SECTION 25 GRAVEL PIT NOISE

SUBJECT: Birchwood Pit Preliminary Watercourses Mapping

SUBJECT: Birchwood Pit Revised Preliminary Watercourses Mapping

This letter is in response to the Municipality of Anchorage (MOA) request for agency comments on a conditional use permit for ADOT&PF to mine gravel. The following recommendations are made by the DEC-Drinking Water Protection Program (DWPP) for the proposed gravel extraction areas located near Eagle River, Alaska, west of the Glenn Highway, within Section 25 of Township 15 North / Range 02 West (Maps 1 and 2). The DEC-DWPP can provide recommendations as they pertain to nearby *public* water systems (PWS) only; not *private* water systems. The DEC-DWPP identified PWSs within a 1-mile radius of the proposed extraction areas, to provide a general picture of the area regarding the relative density of PWSs. The DEC-DWPP identified three PWSs within a 1-mile radius from the proposed extraction areas (Maps 1 and 2). Additionally, one PWS was identified just outside of the 1-mile radius, and approximately "downgradient" of the proposed extraction areas; the groundwater gradient is described as west and northwest in the vicinity of the propos

Figure 1: BirchwoodPit08 Watercourse Features

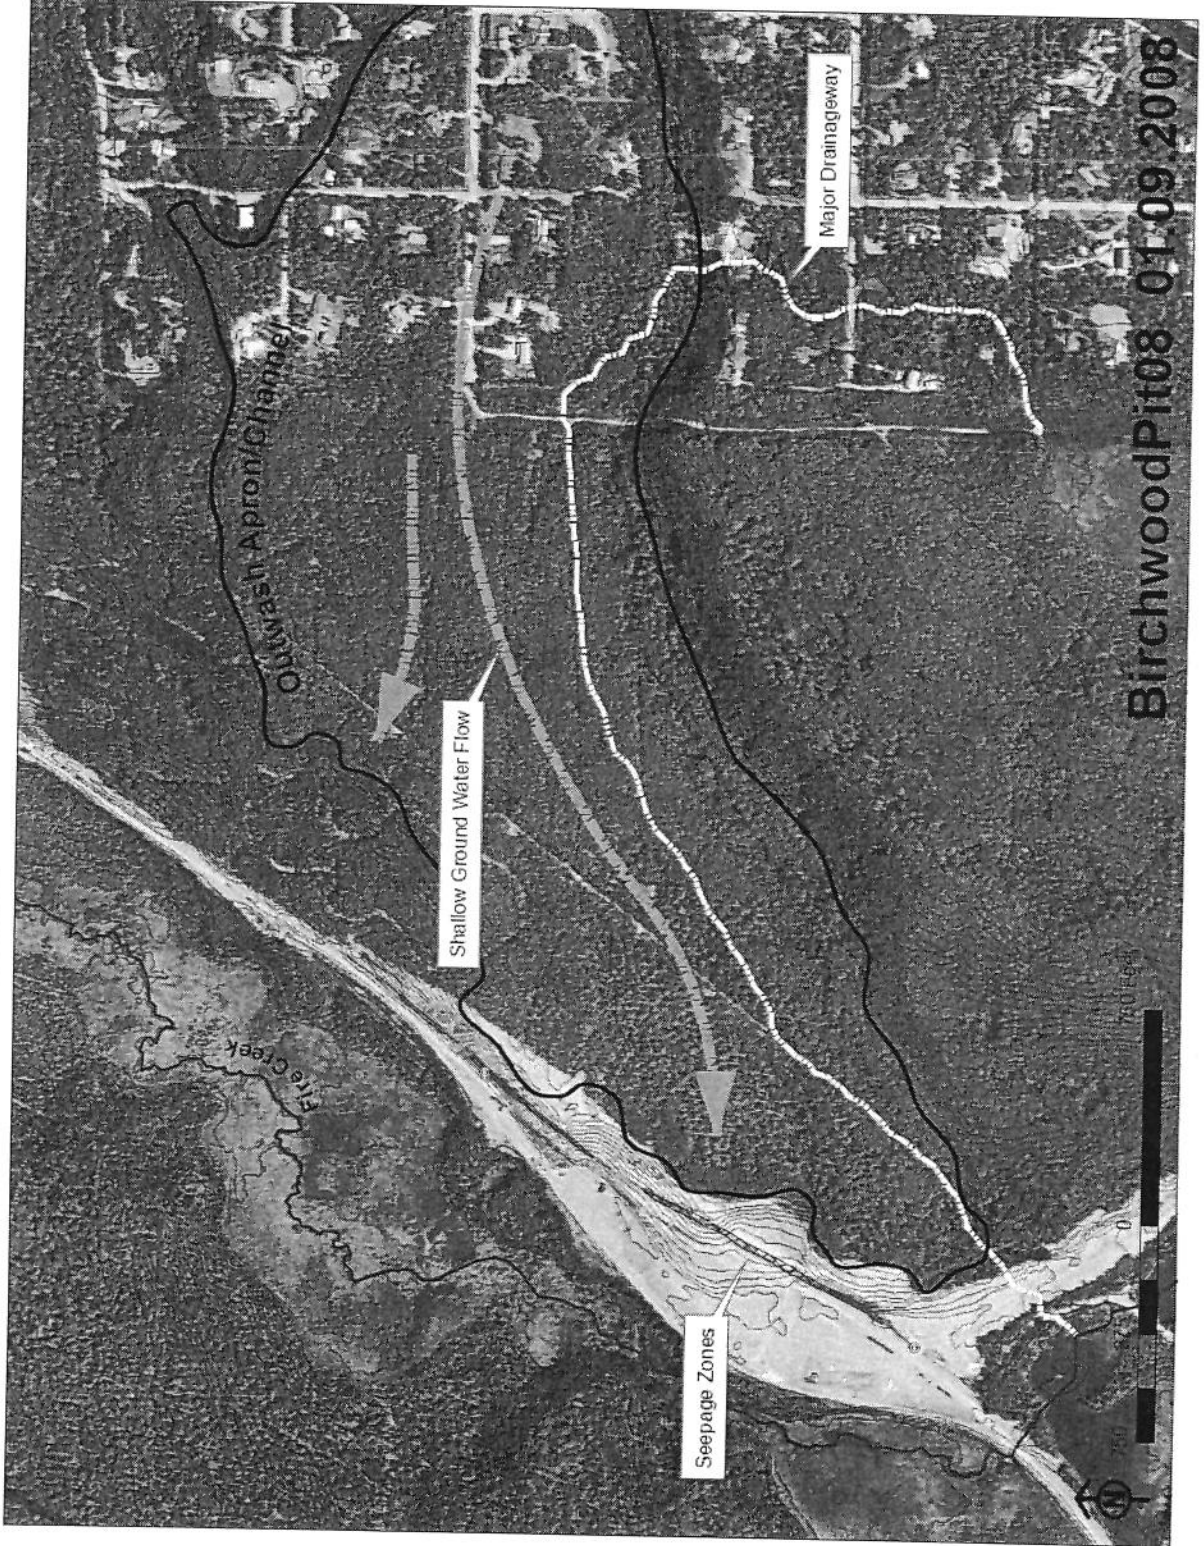
However, we did observe surface flows (a total of about 0.5 cubic feet per second, cfs) in the ARR ditches located along the base of the steep embankment at the west edge of the outwash channel feature. At this point the relatively planar surface of the old outwash channel feature ends and the ground drops abruptly about 30 feet down a steep excavated embankment to the ARR ditch line (and a total of about 85 feet to the modern floodplain of Fire Creek further downslope). At the time of our investigation flows observed in the ARR ditch originated as seeps and springs extending for about 2,300 feet along the cut face of the embankment (Figure 1, 'Seepage Zones'). Surface flows in the ditches generally did not have an ice cover despite the very cold temperatures. The seeps and flowing springs feeding the ditch flows originated at elevations ranging from 0.5 to a few feet above the water surface in the ditch (or about 25 feet below the surface of the outwash floodplain). On the basis of the unfrozen surface water in the ditches and the elevation of the seeps and springs above the ditch water surface, source for the flows is inferred to be local shallow ground water intercepted by the cut banks along the ARR ROW. The greatest volume of flow during our reconnaissance entered the ditches at the southern end of the cut embankment with the contributing ground water flow volume continuously decreasing towards the north. Flows in the ditch ceased altogether beyond the north margin of the outwash channel feature despite railroad ditch elevations much lower than the ditches to the south where contributing flows were at a maximum (Figure 1).

1. Based on our observations to date, there appears to be no stream or ephemeral channel features entering, crossing or exiting the outwash floodplain surface. This finding is generally consistent with the nature of the floodplain surface and its apparent sediment

- composition. Nevertheless, the only field reconnaissance to date was done under full snow cover conditions. *A final reconnaissance following melt of the snow and ice cover is required to confirm the preliminary finding of no streams.*

2. Some consideration for maintenance of continuity and control of surface drainage entering the proposed development area from the west will be required (particularly with increasing upgradient development). This will be particularly important in terms of: prevention of increased erosion along slope breaks (as at pit headwalls); control of increased runoff peaks and volumes; and prevention of deterioration of runoff water quality, particularly as these relate to protection of the Fire Creek floodplain. *Upgradient surface flows should be directed away from the open pit and across dedicated undeveloped floodplain surface.*

3. Considering the flux of shallow ground water concentrated along the outwash floodplain and the overall transmissivity of the sediments comprising it, a 2-foot vertical separation between the pit floor and the shallow ground water table is not likely to adequately protect existing hydrologic systems, including Fire Creek. Development of the pit will remove the existing protective cover of vegetation and fine grain soils from the old floodplain surface. This cover currently serves to filter surface waters that infiltrate and recharge the underlying shallow ground water system. Without this cover, infiltration into the exposed gravels will be rapid, transporting any contaminants in surface runoff much more quickly to the shallow ground water system, and will obviously be faster, the thinner the cover over the saturated zone. Potential for contamination of the shallow ground water system will be further exacerbated by proposed development activities—gravel extraction and processing. These activities will certainly include trafficking of the pit surface by heavy equipment and support vehicles, and most likely the screening, crushing, and washing of raw pit materials. Fugitive leaks, spills and process waters and wastes will be subject to leaching and mobilization with precipitation and runoff. Rate and degree of mobilization of these wastes into the shallow ground water system will be increased by a too-thin gravel cover. Once in the shallow ground water system, mobilized contaminants will be short-circuited to the surface and into nearby Fire Creek by the existing ARR ditch cut. Seasonal fluctuations in shallow ground water elevations are also likely to increase after development of the floodplain surface. Larger fluctuations will result in a significant increase in the average annual maximum elevation of the shallow ground water surface over that currently measured under undeveloped conditions. This means that if excavation proceeds to a depth based on pre-development ground water elevations, the pit surface is likely to be finished with a much smaller separation than the two-feet currently proposed. This could result in additional surface seeps and spring flows across the pit floor where surface contaminants are most likely to have accumulated. Finally, effective capping and restoration of the site after gravel depletion will be made more difficult by a thin separating gravel cover. *Detailed mapping of the average elevation and seasonal variability in the elevation of the shallow ground water table should be completed as part of preliminary development planning. This mapping should include determination of the thickness and width of the unconfined aquifer. In any event, the vertical separation distance between the finished pit floor and the highest seasonal position of the shallow ground water table should not be less than 4 feet.*

4. For all of the reasons discussed above, with poorly controlled or designed pit activities the potential is high for contaminants to enter the shallow ground water system and from there to be short-circuited to the surface and to the adjacent Fire Creek floodplain. Because potential for rapid infiltration to the shallow ground water system will be increased below the pit floor and ground water flow paths to surface discharge points are short, preventing surface runoff from the pit surface alone will not be sufficiently protective of adjacent surface water bodies. These practices may be sufficient to control excessive turbidity from the operating pit but are not likely to be adequate to control other, particularly soluble, contaminants. *Pit operations and practices should include appropriate controls for fueling, parking, and vehicle maintenance, and materials processing, including at minimum appropriately designed pads where infiltration of contaminants generated by these activities can be more readily controlled.*

Figure 1: BirchwoodPit08 Watercourse Features

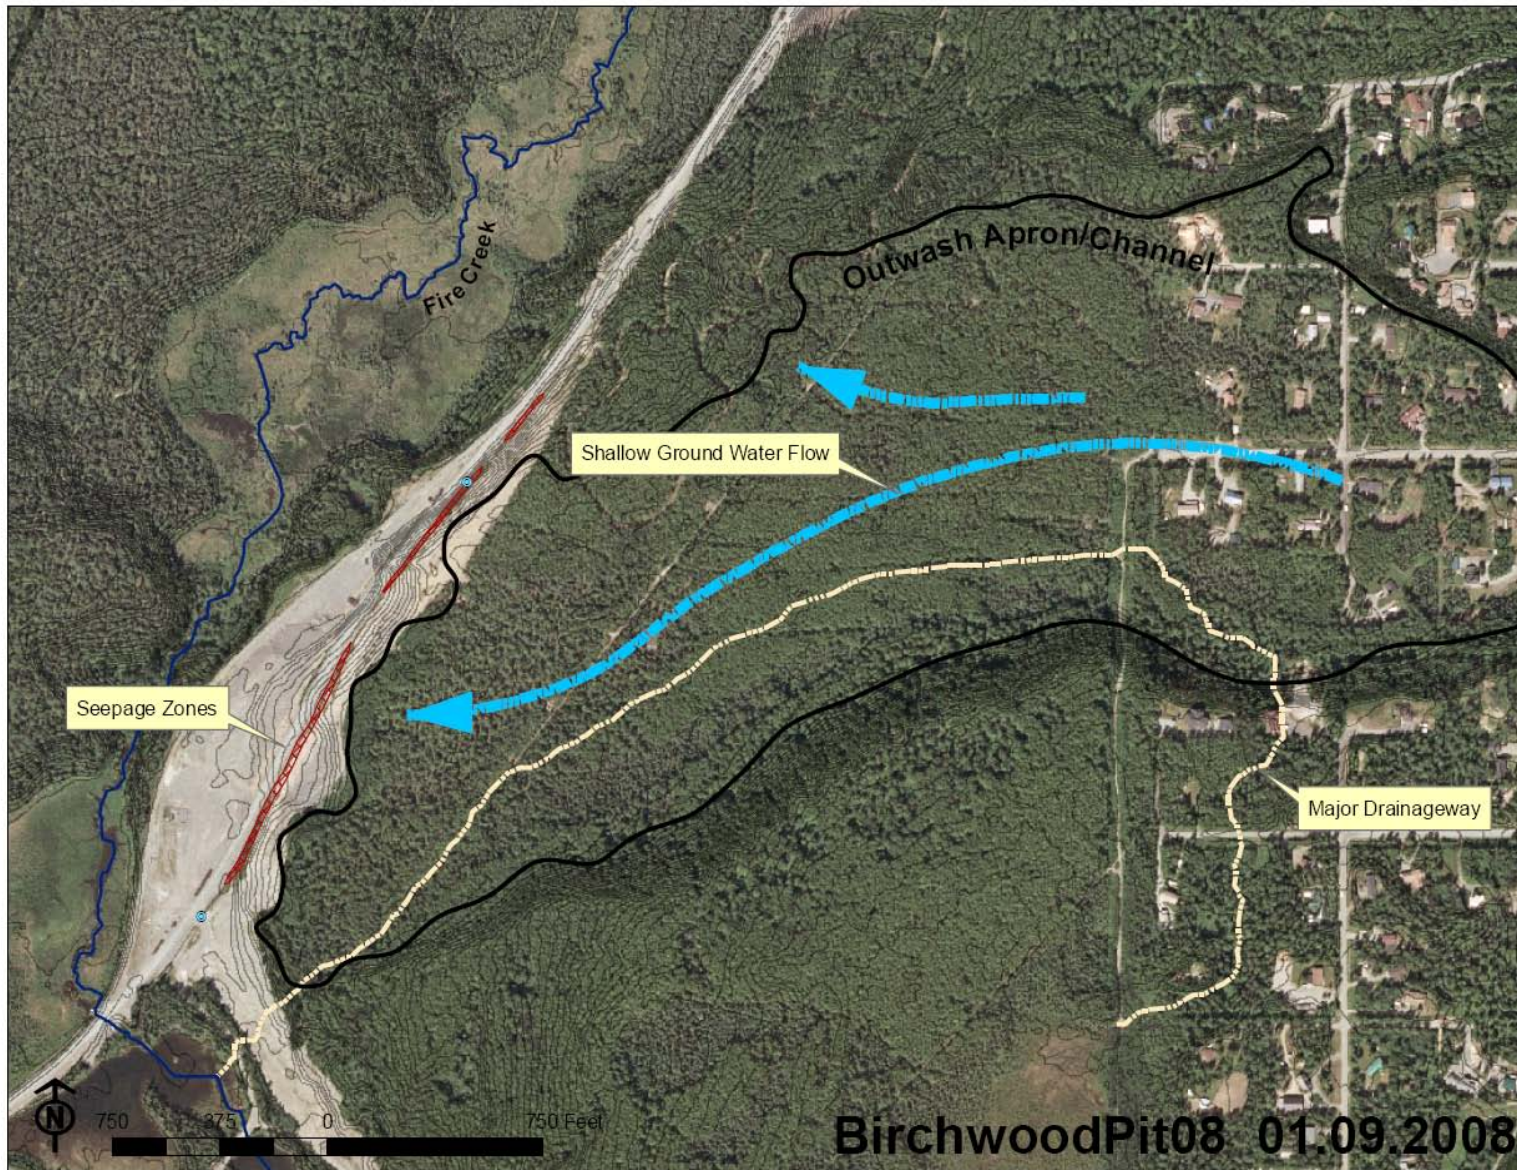
However, we did observe surface flows (a total of about 0.5 cubic feet per second, cfs) in the ARR ditches located along the base of the steep embankment at the west edge of the outwash channel feature. At this point the relatively planar surface of the old outwash channel feature ends and the ground drops abruptly about 30 feet down a steep excavated embankment to the ARR ditch line (and a total of about 85 feet to the modern floodplain of Fire Creek further downslope). At the time of our investigation flows observed in the ARR ditch originated as seeps and springs extending for about 2,300 feet along the cut face of the embankment (Figure 1, 'Seepage Zones'). Surface flows in the ditches generally did not have an ice cover despite the very cold temperatures. The seeps and flowing springs feeding the ditch flows originated at elevations ranging from 0.5 to a few feet above the water surface in the ditch (or about 25 feet below the surface of the outwash floodplain). On the basis of the unfrozen surface water in the ditches and the elevation of the seeps and springs above the ditch water surface, source for the flows is inferred to be local shallow ground water intercepted by the cut banks along the ARR ROW. The greatest volume of flow during our reconnaissance entered the ditches at the southern end of the cut embankment with the contributing ground water flow volume continuously decreasing towards the north. Flows in the ditch ceased altogether beyond the north margin of the outwash channel feature despite railroad ditch elevations much lower than the ditches to the south where contributing flows were at a maximum (Figure 1).

1. Based on our observations to date, there appears to be no stream or ephemeral channel features entering, crossing or exiting the outwash floodplain surface. This finding is generally consistent with the nature of the floodplain surface and its apparent sediment composition. Nevertheless, the only field reconnaissance to date was done under full snow cover conditions.

A final reconnaissance following melt of the snow and ice cover is required to confirm our preliminary finding of no streams.

2. Some consideration for maintenance of continuity and control of surface drainage entering the proposed development area from the west will be required (particularly with increasing upgradient development). This will be particularly important in terms of: prevention of increased erosion along slope breaks (as at pit headwalls); control of increased runoff peaks and volumes; and prevention of deterioration of runoff water quality, particularly as these relate to protection of the Fire Creek floodplain.

Upgradient surface flows should be directed away from the open pit and across dedicated undeveloped floodplain surface. In discussions on February 13 with the applicant's consultants, construction of an upgradient dike around all or a portion of the perimeter of the pit to divert and lengthen the flow path of upgradient storm water seemed a possible alternative solution. However the effectiveness of this alternative is dependant upon little or no upgradient ditching and little or no significant impoundment of flows against the dike.

3. Considering the flux of shallow ground water concentrated along the outwash floodplain and the overall transmissivity of the sediments comprising it, the minimal 2-foot vertical separation proposed between the finished pit floor and the shallow ground water table will (a) significantly increase the sensitivity of these systems and adjacent surface receiving waters to water quality impacts and (b) significantly increase costs of restoring or using the completed pit for other landuses.

Detailed mapping of the average elevation and seasonal variability in the elevation of the shallow ground water table should be completed as part of preliminary development planning. This mapping should include determination of the thickness and width of the unconfined aquifer. In any event, the vertical separation distance between the finished pit floor and the highest seasonal position of the shallow ground water table should be carefully reconsidered based on actual limitations that such a selected separation distance will have on development, maintenance and water quality protection costs for proposed restoration landuses. If post-pit landuse options are to be optimum (excluding on-site systems), minimum separation distance should be established at 42 inches.

4. Removal of the original soil and gravel cover significantly increases potential for contamination of the shallow ground water system and adjacent receiving waters, with risk increasing as the finished separation distance between the finished surface and shallow ground water decreases. The proposed location of gravel extraction and processing operations near the ARR further increases risks to adjacent Fire Creek. These activities will certainly include trafficking of the pit surface and nearby roadways by heavy equipment and support vehicles, most likely the screening, crushing, and washing of raw pit materials, and reportedly asphalt plant operations. Fugitive leaks, spills and process waters and wastes will be subject to leaching and mobilization with precipitation and runoff and, without proper control, have a high potential for directly entering Fire Creek in surface runoff. Whether as surface spills or through the shallow ground water system, mobilized contaminants would be very rapidly mobilized into nearby Fire Creek through the existing ARR ditch cut.

Pit operations and practices should include appropriate specialized controls for fueling, parking, and vehicle maintenance, and materials processing, including at minimum appropriately designed pads and diking so that infiltration and runoff of contaminants generated by these activities can be more readily controlled. Measures to control surface runoff and infiltration of contaminants must be most carefully considered in the proposed staging areas near the ARR where surface and subsurface paths to Fire Creek are extremely short and the shallow ground water table is likely to be very near the surface year-round. Control measures may be phased in terms of their areal extent but should be fully in place at all phases of pit development. Finally, active inspection and enforcement measures by agencies other than pit contractors should be established and in place, with required controls and good housekeeping practices explicitly stated in operational and permitting documents, prior to the start of pit development.
